**KIRKLEES SAFETY AUDIT BRIEF – Internal Audits**

<b>Scheme Name</b>	Rowley Lane S278	<b>Budget Code</b>	50/61868	<b>Lead Designer</b>	Haigh Huddleston & Associates (RSA request Zulqarnain Azam)
<b>Location</b>	Rowley Lane, Fenay Bridge				
<b>Type of Scheme</b>	S278 scheme including new access for housing estate, new uncontrolled crossings, bus stop relocation, revisions to Rowley Lane / A629 junction

**APPENDIX A - VER 1 Kirklees Road Safety Audit Procedures – SPD – Internal Audits**

**Location 1** – (a) Eastbound bus-stop / proposed access, (b) Westbound bus-stop / proposed pedestrian crossing

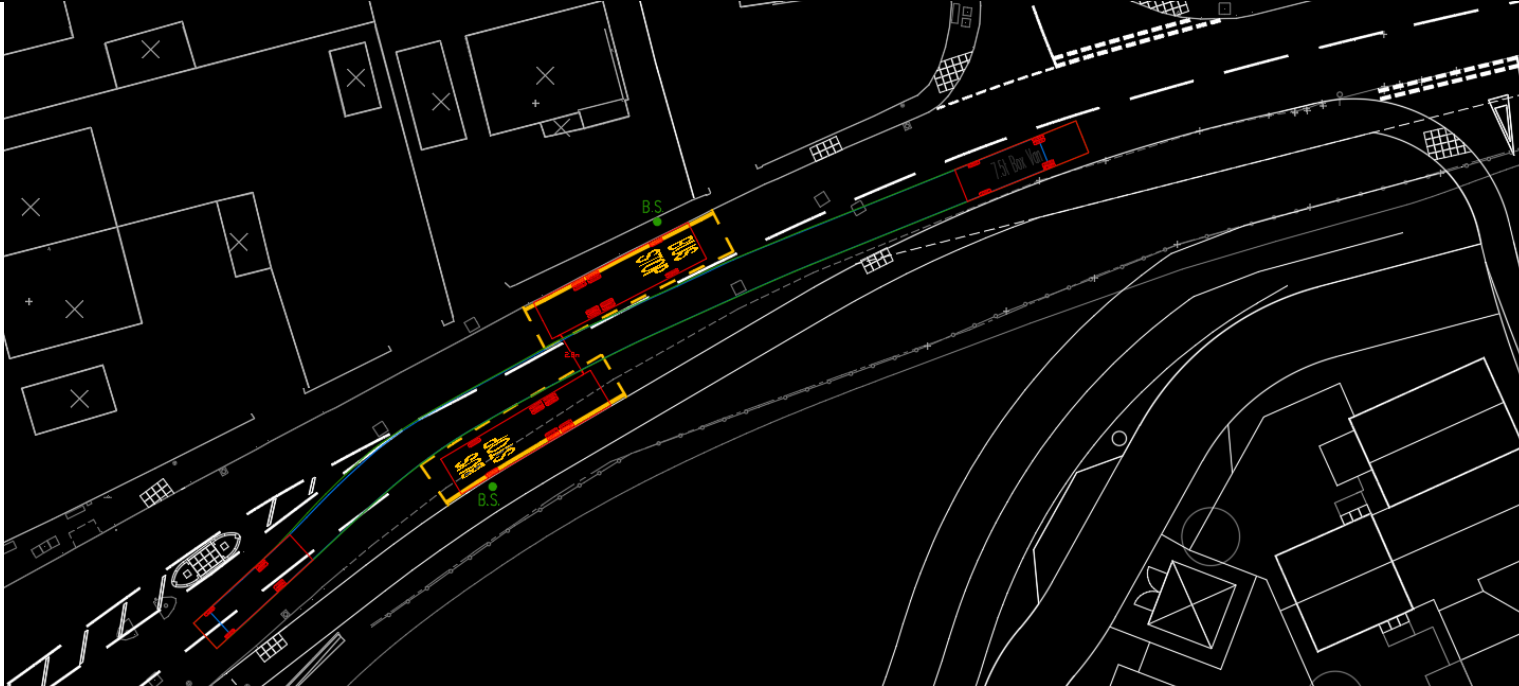
At location (a), it is proposed to retain the existing eastbound bus-stop positioned between Woodsome Drive and the proposed development access. Bus drivers stopping here would be likely to try and clear the Woodsome Drive junction to avoid blocking it, coming to rest partially or wholly opposite the new junction mouth, which could create conflicts with vehicles turning there. Left turns out by larger vehicles would be difficult – the swept paths provided clearly evidence the need to swing out into this area – and collisions could occur. Drivers intending to turn right into the access pulling out to pass a bus in advance of the junction may remain to the offside, increasing their exposure to oncoming traffic. Subsequently, they may execute the turn from the wrong side of the road, potentially conflicting with any vehicle that may be waiting to turn out of the new access.

The westbound bus-stop is proposed to be relocated to location (b), where a new pedestrian crossing of Rowley Lane would also be positioned. Due to the proximity of these features to each other, when a bus stops, the crossing would be blocked. This is inappropriate and could place pedestrians at risk when buses were present, especially visually impaired pedestrians crossing from north to south, who would be directed into the side of the bus by the tactile paving.

It is recommended that both bus stops are relocated westwards to the section of Rowley Lane proposed to be widened, where there would be no conflicts with the proposed access, reduced conflict with the pedestrian crossing (also see related Recommendation 7), and more carriageway width for through traffic to overtake stationary buses – see sketch on following page. New conflicts with driveway visibility are acknowledged and unavoidable but would be far less concerning than the currently proposed situation. Relocation would also reduce the pre-existing conflicts between the eastbound stop and traffic using Woodsome Drive junction.

Bus stop locations to be relocated to suit auditors' recommendation.

Problem closed.

**Location 2** – Proposed access junction

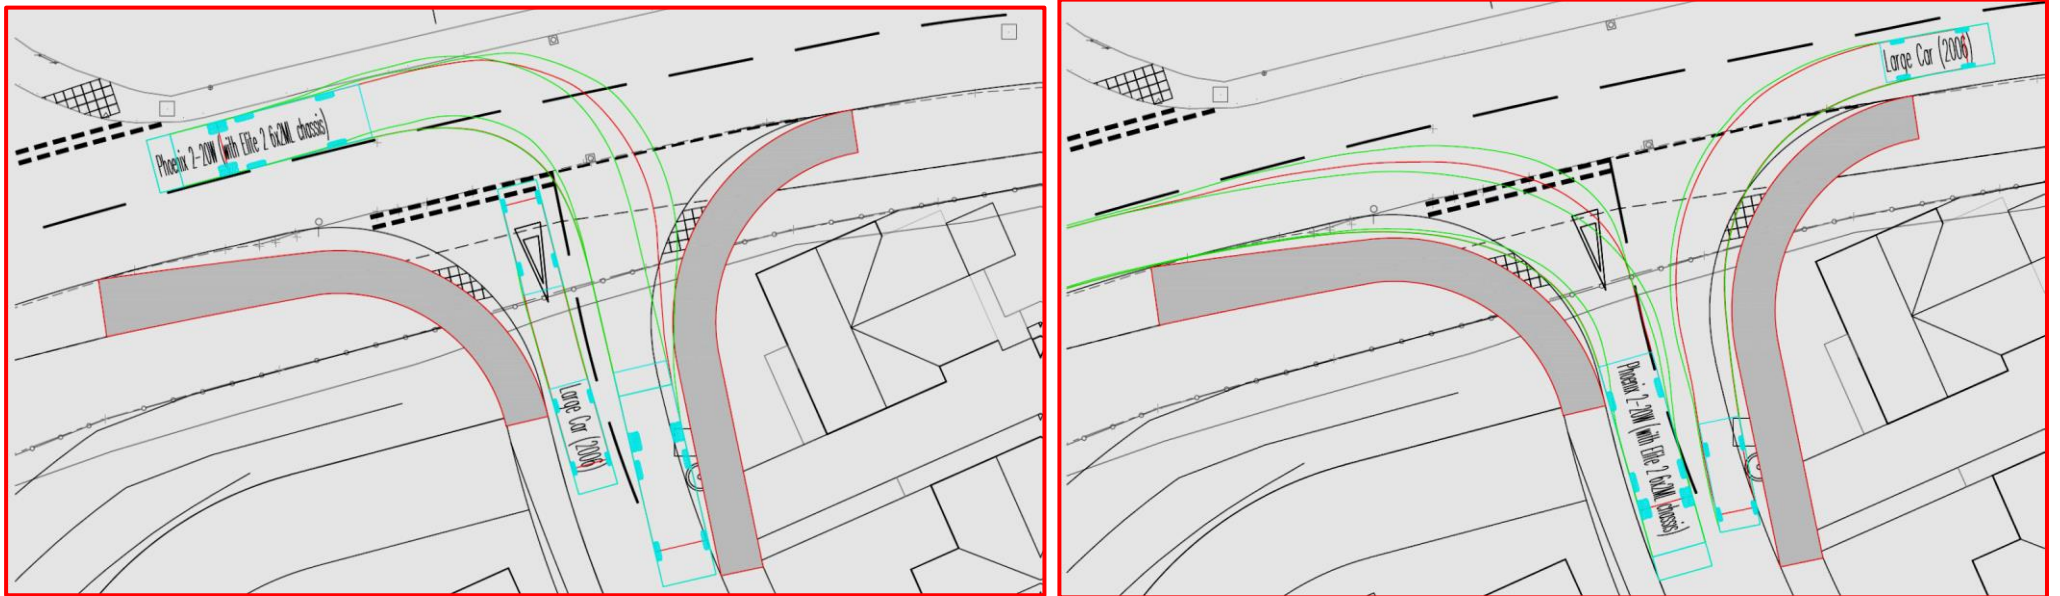
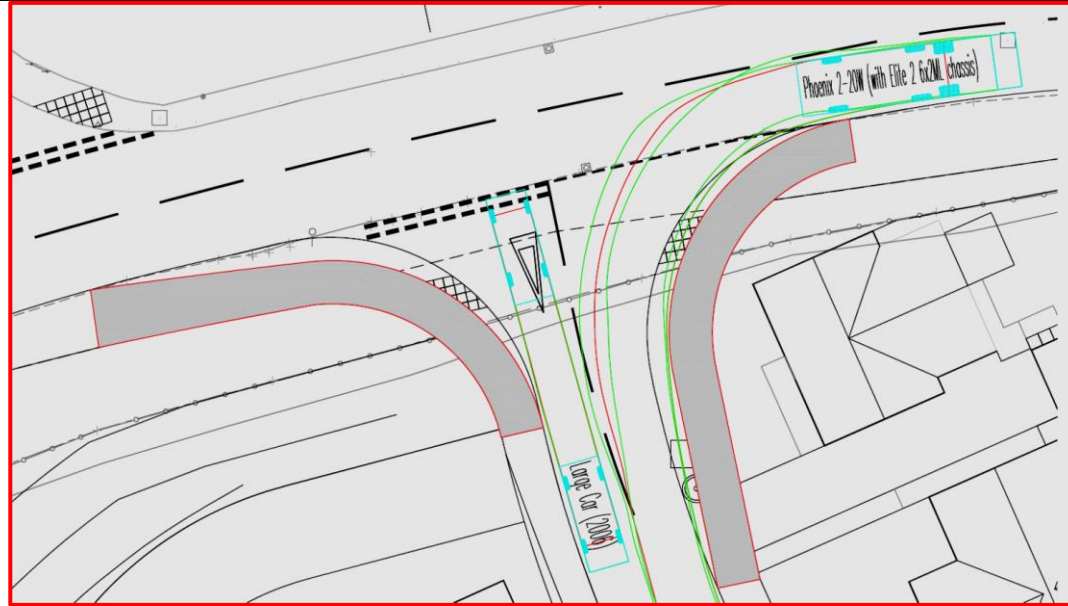
The swept paths show encroachment across oncoming traffic lanes by the Refuse vehicle executing all manoeuvres, but especially left turns. This increases the likelihood of collisions and injuries when opposing traffic is present. Although refuse vehicles may only visit occasionally, there would be similar levels of encroachment by *any* large vehicle, and deliveries (for example) could be frequent.

It is recommended that junction geometry is eased. One option would be to provide 1m x 10m tapers for the trailing edges of left turning vehicles (which would also reduce lane overrun by larger vehicles turning right in).

Width / crossing distance through the junction mouth arising from the addition of tapers would not increase to such a degree that the RSA Team would consider a refuge island necessary (and there would not be adequate room to provide one without significantly changing the layout). Regardless, the numbers of pedestrians crossing through the junction mouth would be extremely low and highly unlikely to carry significant risk, because pedestrians on wider east-west trips would be using the continuous footway along the northern side of Rowley Lane. Crossing movements would be unlikely here other than by residents of the estate.

The problem is unrelated to junction visibility; it concerns restricted space for turning in the junction mouth. It is not reasonable or necessary to expect vehicles turning left-in to the development (for example) to have to stop and wait in the major road whilst another vehicle turns out. With the tapers installed, refuse and delivery vehicles executing turns could do so without conflicting with other traffic within the junction mouth, or on the main road, covering off most traffic scenarios. Whilst issues with lack of space to pass larger vehicles would still occur further south within the estate itself, it is far more important that such issues are not encountered within or close to the junction mouth (where speed differentials are highest with main road traffic), and injury collisions could occur. The changes would also reduce the likelihood of damage to kerbs around the radii. See sketches on following page (based upon unchanged radii with 1m x 10m tapers).

The tapers should be added, or an Exceptions Report provided.

We do not agree with the recommendations of the auditors. An increased junction width would increase the crossing distance for pedestrians resulting in a need for a refuge island. The presence of a central island would make HGV turning much more restricted and worsen the problem.

The existing bank along the southern side of Rowley Lane is to have all vegetation removed and be re-graded to provide an increased visibility at the junction. It is therefore reasonable to expect HGVs to wait until both lanes are clear before making a turn.

**Location 3** – Rowley Lane approach to A629

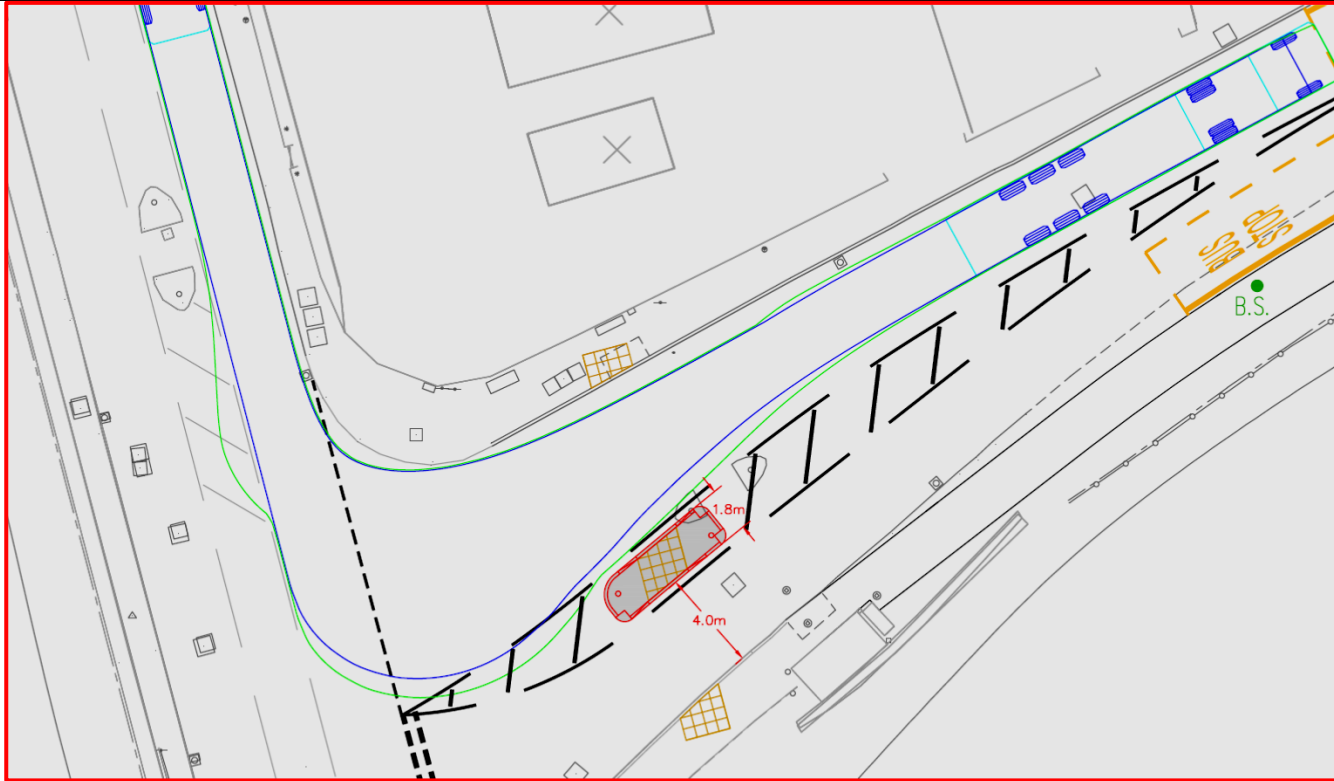
The proposals include widening of Rowley Lane along the approach to the A629 junction, to facilitate a formal two-lane layout with left/right directional arrows. Whilst it is accepted under the existing layout that informal two-lane queuing does occur, the proposal to formally promote two-lanes over a 34m section may have adverse consequences for user safety, which need due consideration.

It is recommended that a single lane approach is maintained, and furthermore, that the refuge is widened to 2m or more to aid NMUs, and to physically discourage the formation of two lanes. Under a single lane layout, the island could be moved much closer to the A629 pedestrian desire line, where it would also be more effective in discouraging two-lane queueing.

The recommendation was for a single lane approach to be maintained, and for the refuge to be widened and moved closer to the crossing desire line. The Designers appear to have just removed the lane marking which achieves little, as there would still be adequate space for two-lane queuing past the refuge by cars, and the crossing would still be setback an excessive distance from the A629, so the hazards would remain. The westbound approach lane should be physically narrowed to [say] 4m by widening the refuge, and the refuge moved west. The sketch below shows a layout reflecting these outcomes, and all manoeuvres are achievable by a 2016 FTA Design Articulated vehicle, with the left turn in being no more restricted than the Designer's path (as infrequently as vehicles this large would be likely to execute the manoeuvre).

A similar layout should be adopted, or an Exceptions Report provided.

Junction designs to be altered to reflect a single lane approach as recommended by the auditors.

The Stage 1 RSA highlighted concerns with articulated HGVs mounting the pavement when turning Left into Rowley Lane. The pedestrian island and crossing point was therefore moved further North to allow HGVs additional turning space and alleviate the issue. The crossing point should therefore remain in its current position with an increased island width to suit the recommendations of the auditor.

**Location 4** – Rowley Lane at junction with Woodsome Drive

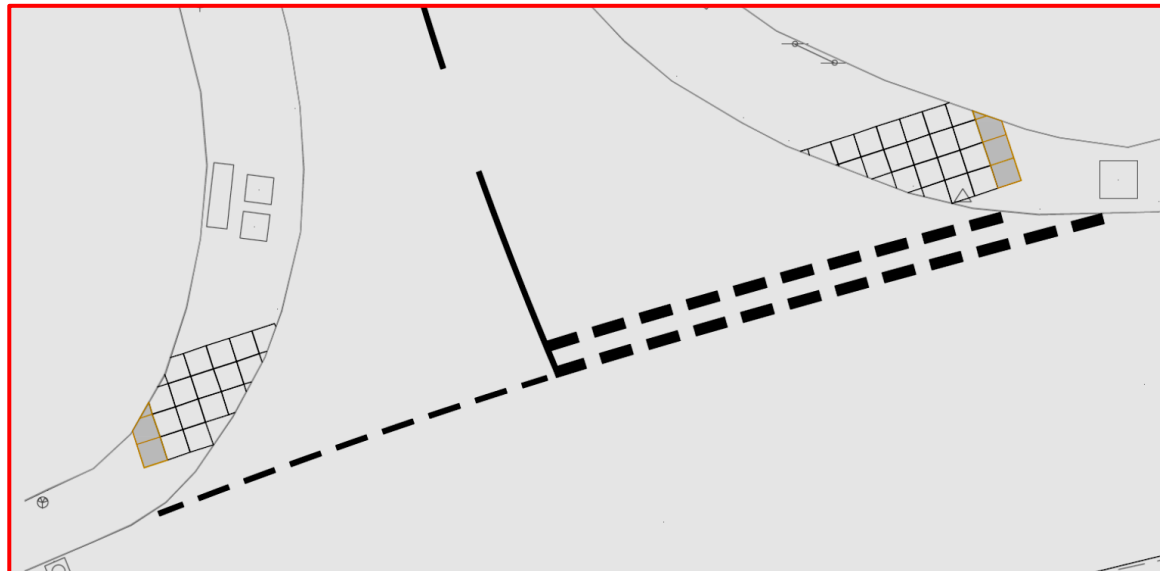
The proposals include blister tactile paving areas for the east-west crossing paths along the northern side of Rowley Lane, through the Woodsome Drive junction mouth. At their narrowest (Rowley Lane sides) these paving areas are shown at two blocks deep. At this depth, the paving could be inadvertently stepped over by visually impaired pedestrians approaching them in-line with the crossing direction. This could lead to them unknowingly entering the live carriageway in the junction mouth and being struck by vehicles.

It is recommended that the minimum depth of the tactile paving areas be increased to three blocks (as per *Guidance on the Use of Tactile Paving Surfaces* advice – DfT).

The Designers misunderstand the situation. As per *Guidance on the Use of Tactile Paving Surfaces*, an additional row of blister paving must be provided on each side of the Woodsome Drive junction as indicated below, or an Exceptions Report will be required.

The existing footpath width along Rowley Lane and Woodsome Drive restricts available space for tactile paving. Wherever possible tactile paving should be increase to 3 blocks deep.

**Location 5** – Proposed access junction mouth, eastern side

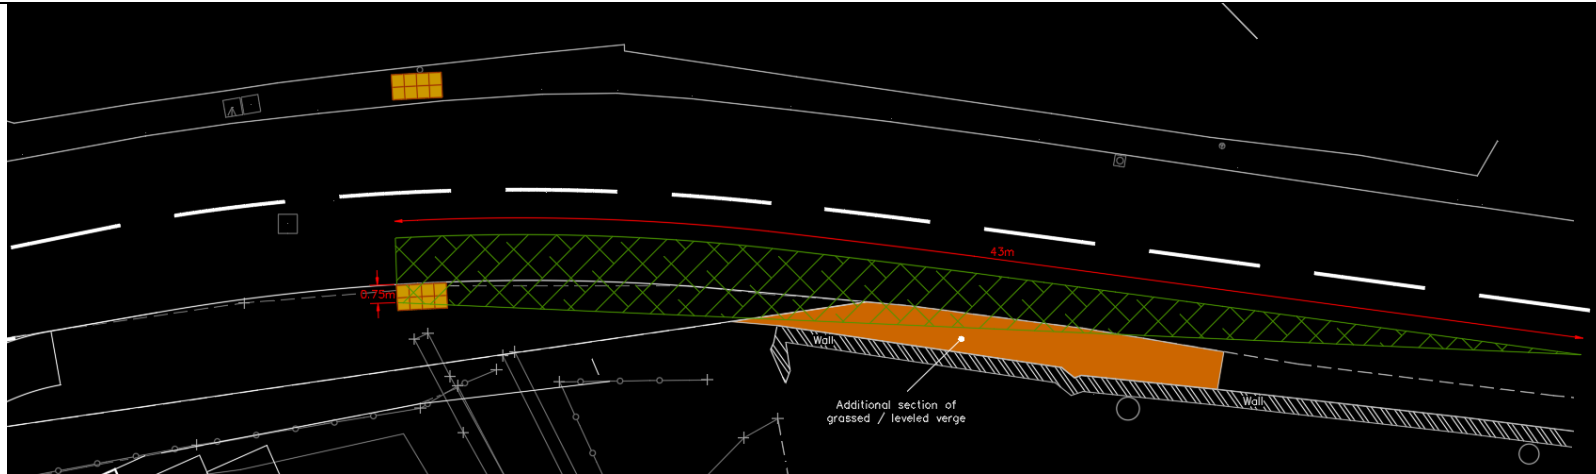
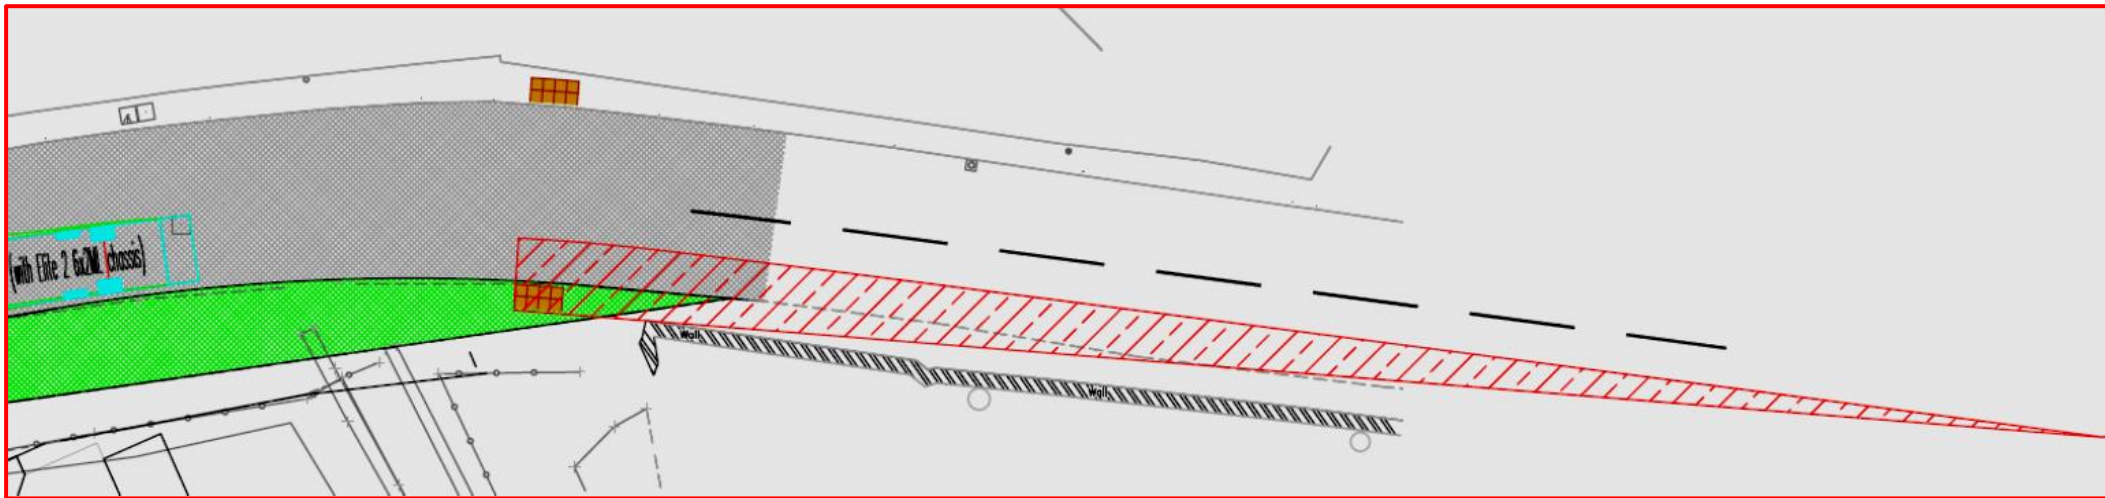
The proposals include tactile paving areas and flush kerbs at both sides of the development access, to facilitate east-west crossing movements. On the eastern side, however, the area of tarmac continues around the radius some distance beyond the crossing point, before changing to grass as it ties-in with Rowley Lane. Any pedestrian wishing to head east along Rowley Lane from the development would be highly likely to walk around this tarmacked section before crossing Rowley Lane at the boundary of the junction mouth (and vice versa), rather than using the promoted crossing point being proposed further west, which is way off-line. This would be hazardous.

It is recommended that the hardened footway section is extended to the east by some 15 to 20m to the apex of the curve on Rowley Lane, where another uncontrolled crossing should be promoted. Considering the risks that pedestrians would no doubt take crossing Rowley Lane close to the development junction when following desire lines (if the layout remained as Audited), on balance, it is highly likely to be safer to relax visibility requirements for a crossing point east of the access, by reducing setback of the splay from the carriageway edge ('X distance') from 1.5m DMRB recommended to 0.75m. It appears that 43m of visibility would then be achievable from the centre of the approach lane. An extension of the levelled grass verge should be provided (within the highway boundary) east of the Developer's boundary at the front of the natural stone wall, with all free growing plants permanently removed. Tree canopy trimming and removal of other growth should also be carried out above / behind the wall, see sketch. Note, the position shown below may not be the best in terms of visibility, and the Designer should identify the best option.

Experience shows that pedestrians will take the most direct possible route between their location and destination regardless of designers' intentions. This is especially true where the intended route is significantly longer, heads in a directly opposite direction to that desired, and includes nothing more than an uncontrolled crossing point to 'encourage' its use (a much stronger argument would be valid if it was a controlled crossing). Most journeys on foot will be between the estate and facilities in Fenay Bridge / Lepton, east of the site. It is inconceivable to the RSA Team that pedestrians leaving the estate (for example) would be prepared to divert in the opposite direction to walk up to 150m farther than they would otherwise have to, regardless of any 'discouragement' through providing non-hardened surfaces in the eastern verge of the access. Pedestrians will cross Rowley Lane here.

The recommendation stated that the Designer should identify the best option for a crossing. See sketch below. This crossing is positioned at the eastern limit of the area already being cleared for the junction visibility splay, with the eastern side of the crossing aligning with where verge width reduces to 1.5m. The visibility splay shown is based upon 59m SSD, corresponding to 85<sup>th</sup> percentile approach speeds of 35mph (MfS), which is

A crossing point should be incorporated, or an Exceptions Report provided.

We do not agree with the recommendations of the auditors. The crossing point would be located on a downhill sweeping bend where vehicle speeds may be high. The highlighted section of ground for the visibility splay is narrow and unlikely to be maintained in the future which may worsen visibility at the crossing point. We would therefore recommend that the existing crossing locations are maintained.

The footpath on the East side of the site entrance should be reduced in length to discourage pedestrians from walking beyond the crossing point to cross Rowley Lane.
